Subject: Zoning By-Law Amendment – Part of 780 Baseline Road and 7 and 9 Hilliard Avenue

File Number: ACS2023-PRE-PS-0137

Report to Planning and Housing Committee on 29 November 2023

Figure 1. Shade maps for 780 Baseline Road. Top Map includes Tower A 78m, B 78 m and C 102m. Bottom map is only for Tower A 78m.

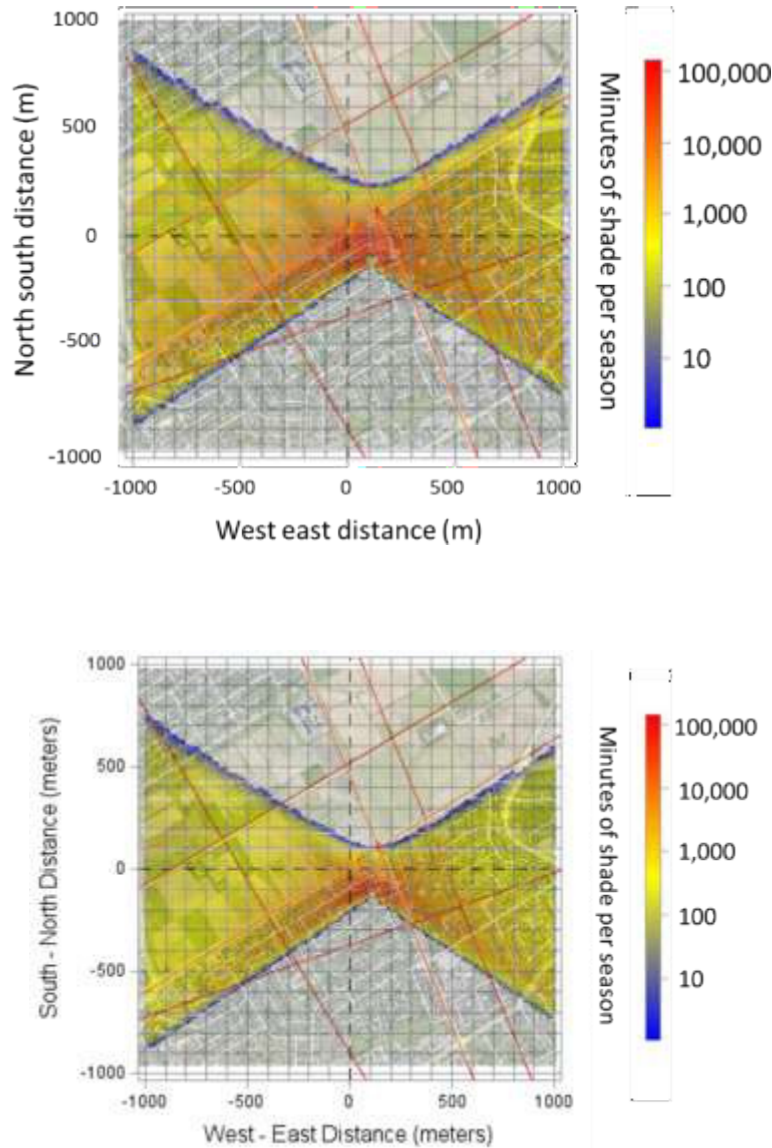
1. The attached figure 1 shows a 4 km² block centred on the proposed towers at 780 Baseline Road. The colours over the area correspond to the shaded land with red being the greatest amount of shade followed by yellow and dark blue. The units are cumulative minutes of shade during the growing season. The figure shows that the proposed towers will result in significant shade cast on the CEF research lands both east and west of Fisher Avenue.

Figure 2a. Percent daily reduction in solar radiation April 01 to November 30 for Tower A, B and C at 780 Baseline Road. Polygon colours correspond to percentage daily amount of solar radiation reduction

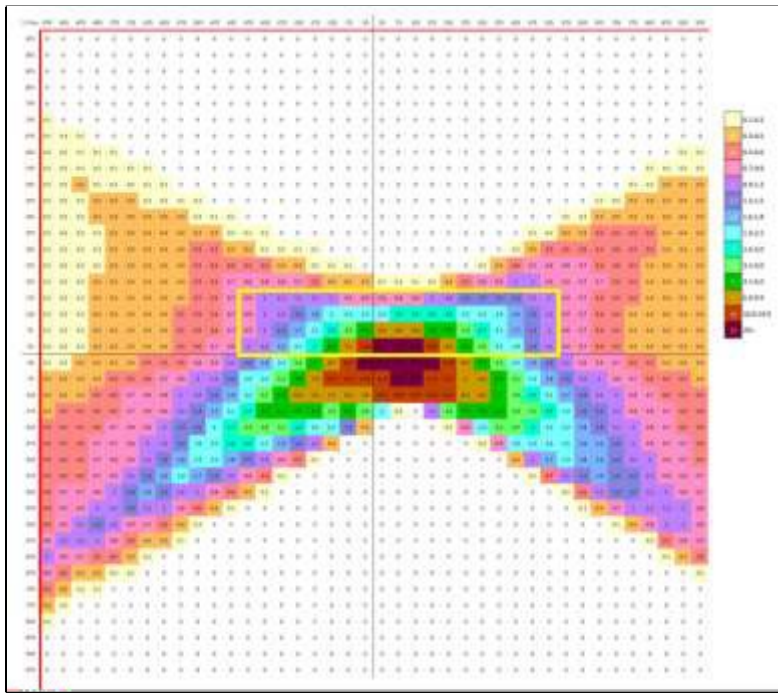
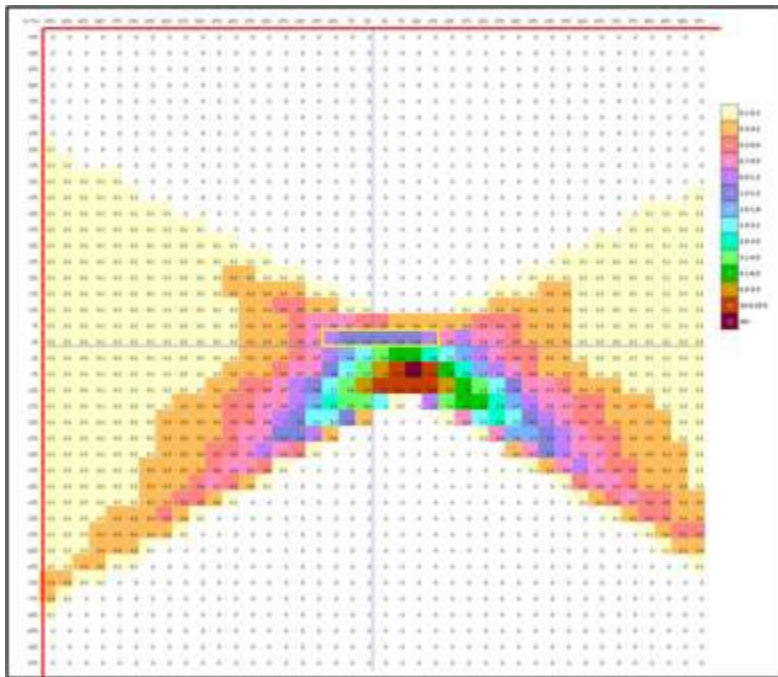
2. Figures 2a and 2b have been developed based upon 50 m² polygons and show the percentage of light reduction per day for the growing season. The research lands directly opposite the proposed development will have daily solar radiation reduced by ~13 percent per day. Moving west from Fisher the amount of shade received on the land is reduced until by 400 m from the towers it is less than 1% of solar radiation reduced per day. Moving north from the proposed towers, solar radiation reduction decreases and at 200 m it is less than 1% per day.

4. The yellow rectangles on Figure 2a and 2b show the area of research lands that will be detrimentally affected by the reduction in solar radiation.
5. Reducing the total amount of light reaching the research lands will reduce total plant photosynthesis, reducing yield and delaying harvest.

7. As seen in Figure 2b, the shade from only tower A is much less devastating to CEF research lands than when combined with Towers B and C. This is not only from the 24 m reduction in height of tower A, but also its placement ~ 75m south of baseline road.
